UNITED STATES PATENT AND TRADEMARK OFFICE

Office Action Summary

10/799,939

WORRICK ET AL.

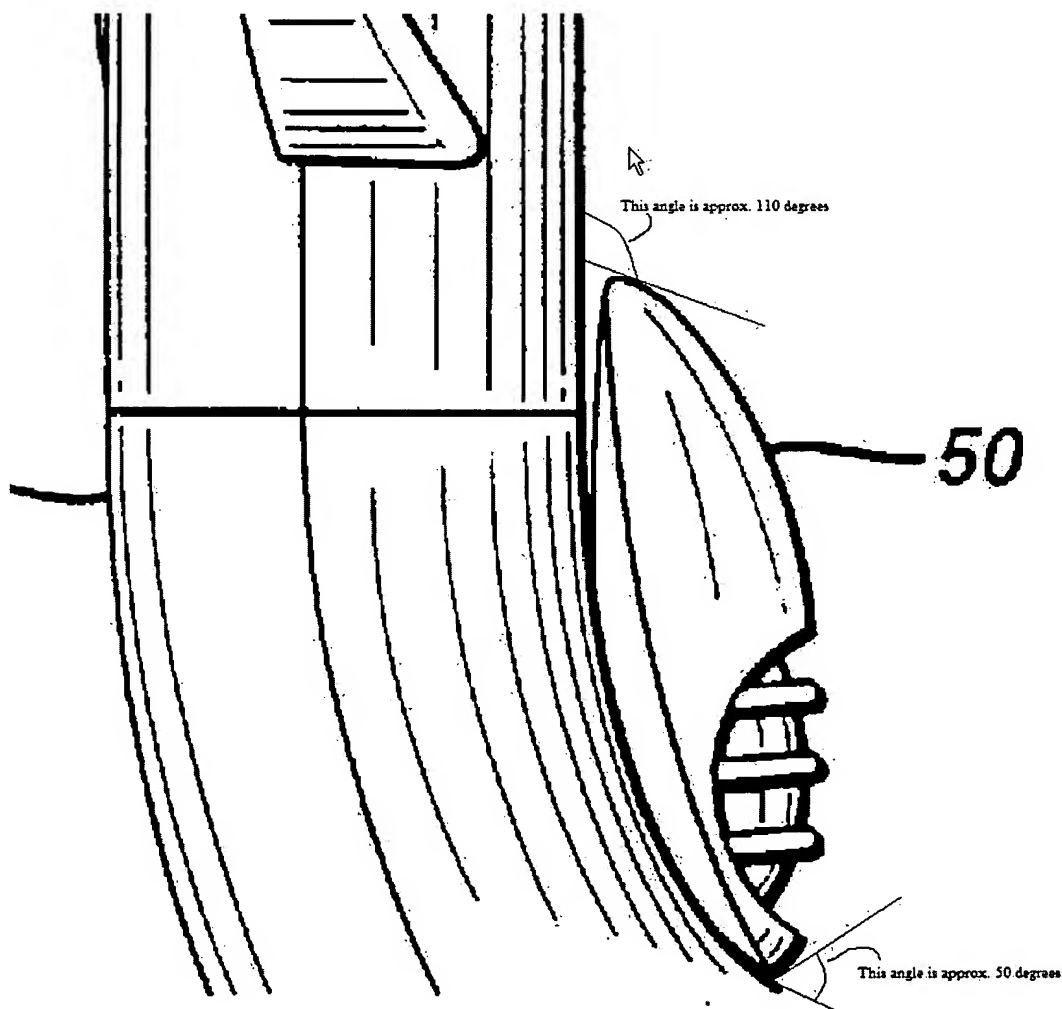
Regarding claim 7 Apprille'071 discloses that the edge of the canopy contacts the handle casing having an angle of no greater than 110 degrees. This is because the angle formed between the button and the handle casing varies and is at a maximum in the front center region of the canopy, which at no time is greater than 110 degrees (#50 is in contact with #12, figures 16 & 17). See the figure below.

Regarding claims 8, 10, 19 and 21 Apprille'071 discloses that the edge of the canopy of the shaving razor disclosed above contacts the handle casing having an angle which varies around the periphery and has a maximum at "a center region" of the canopy. This is seen in the figure above, from Figure 18 of Apprille'071.

Regarding claim 18 Apprille'071 discloses that the edge of the canopy of the shaving razor disclosed above (in section 8) having an angle of no greater than 110 degrees. This is because the angle formed between the button and the handle casing varies and is at a maximum in the front center region of the canopy, which at no time is greater than 110 degrees (#50 is in contact with #12, figures 16 & 17). See the figure above.
